RETAINING WALL AT CALAROGA AVENUE

GENERAL PLAN

AS BUILT PLANS
Contract No. 04-167624
Date Completed -
Document No. 4-111 8137

Typical Revised Section
Sta 277+50 to 282+00

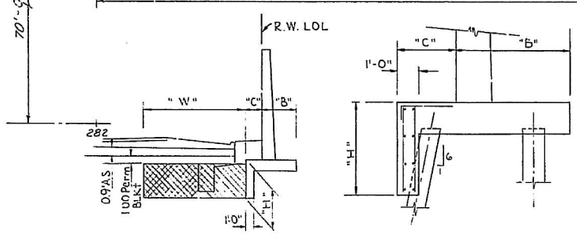
Note:
Longitudinal dimensions are measured along ret. wall layout line.
Piles shown thus: ⊙ at Revised Sections
Piles battered 1:3 shown thus: ⊙
For details of ripped texture see "Retaining Wall Layout No. 4" sheet.

RETAINING WALL LAYOUT NO. 2

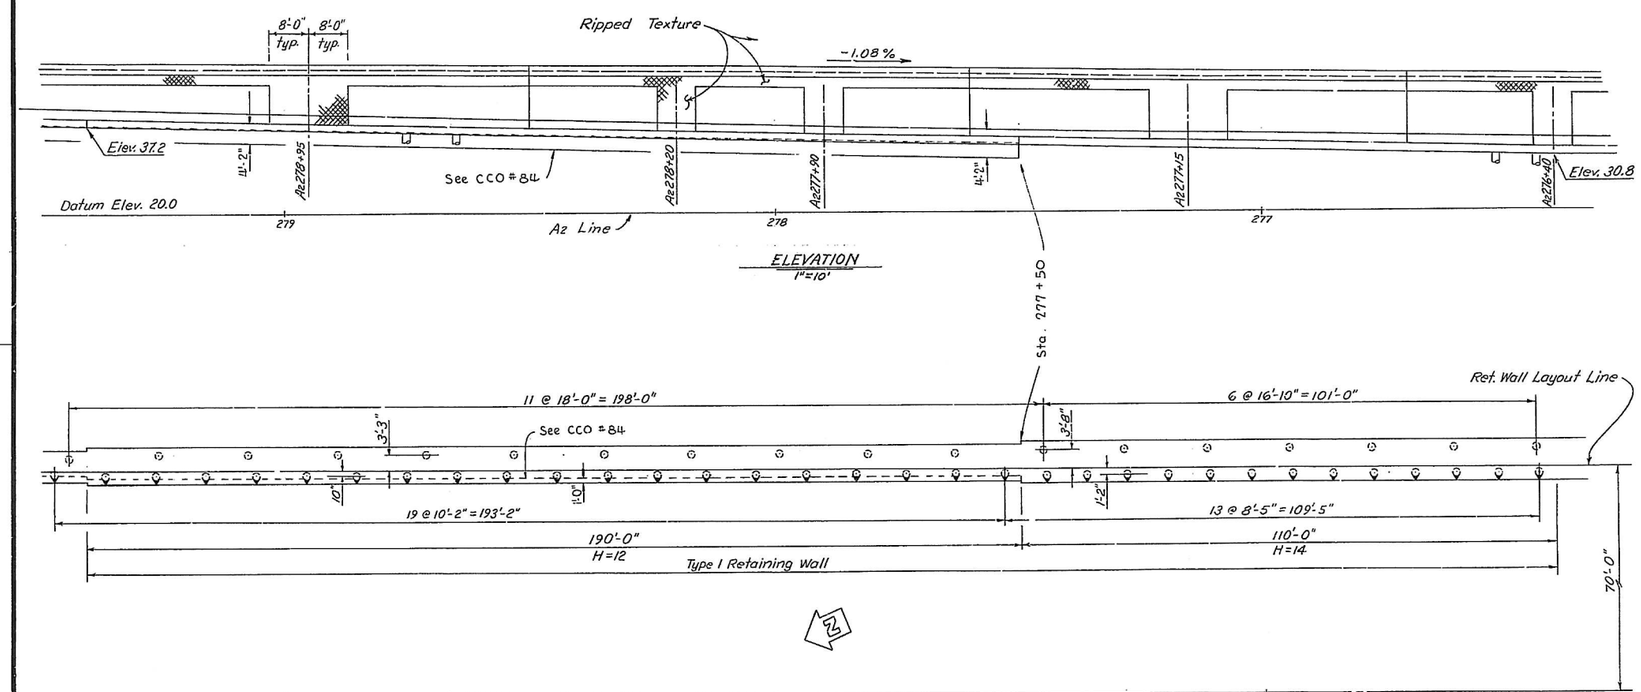
AS BUILT
CORRECTIONS BY S. Nivarenko
CONTRACT NO. 04-167624
DATE 12/75

45T PILE FOOTING SECTION
H=4 Thru H=22

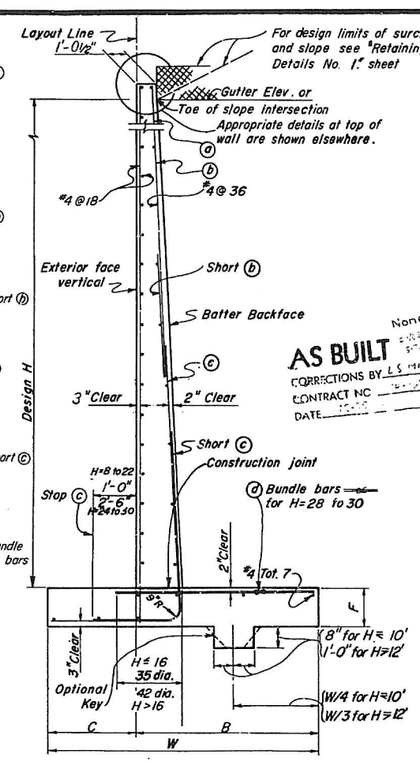
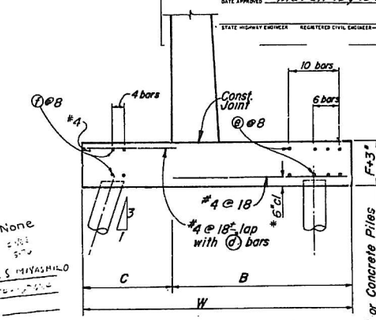
Note:
Clearance to front face reinf. and wall thickness revised.

1 REV. ELEV, TABLE, PILE FTG SEC (4 thru 22) 6/72

PRECAST SOUND BARRIER WALL
A2 ~~277+00~~ 279+46.25 TO A2 ~~282+91~~ 286+00.40

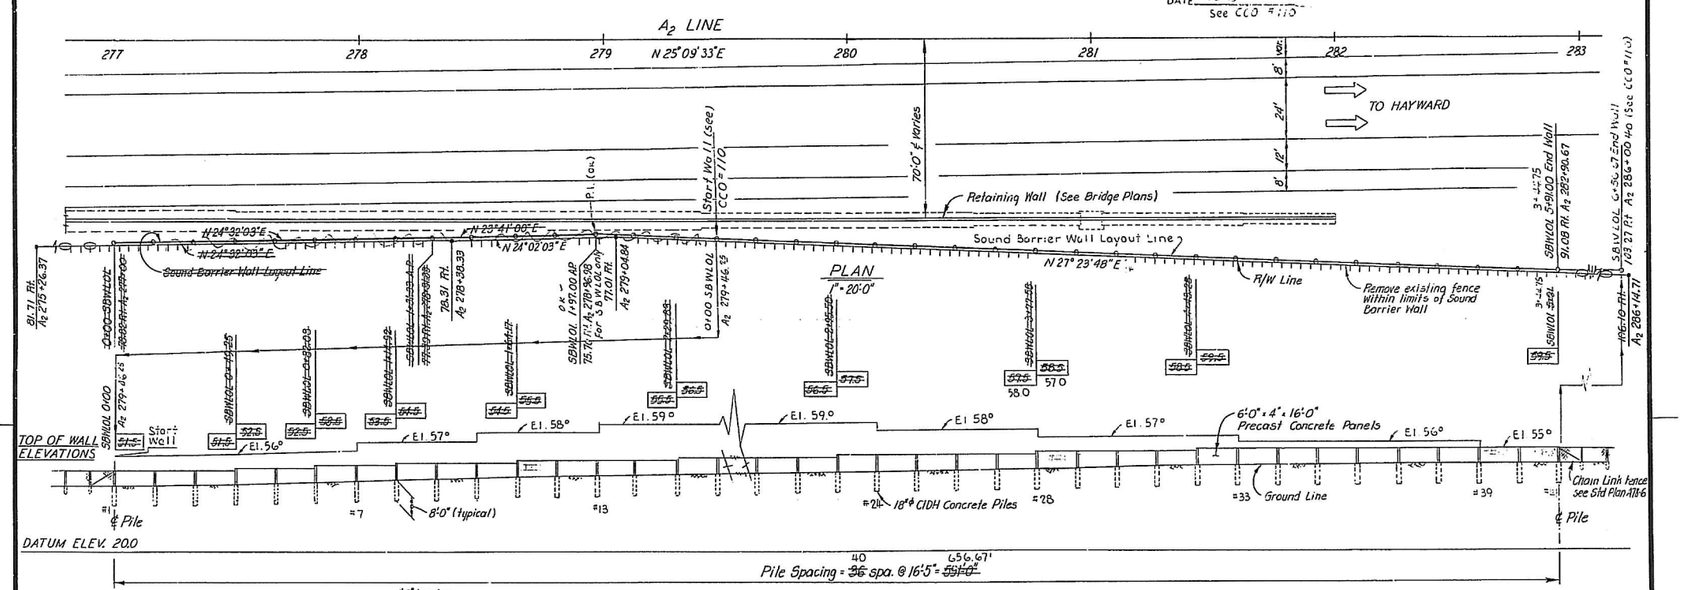
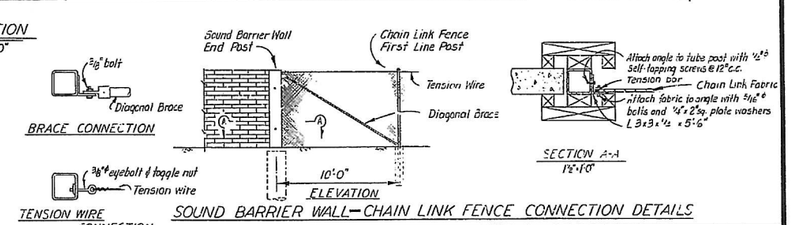
See CCO #110
